PSE Inrush for D1.6 v101

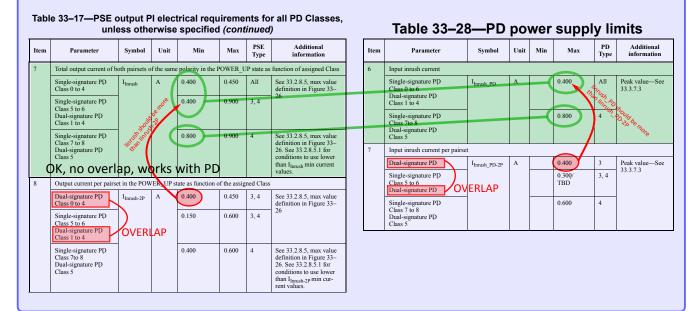
When implementing the inrush baseline for D1.6, the comment instruction said to remove all distinction between dual-signature with same or different class. This has caused part of the disconnect between total and pairset currents as well as between the PSE and the PD specification. The total inrush currents I_{Inrush} and I_{Inrush_PD} seem to be OK and compatible with each other. These have been taken as leading.

Trouble illustrated:
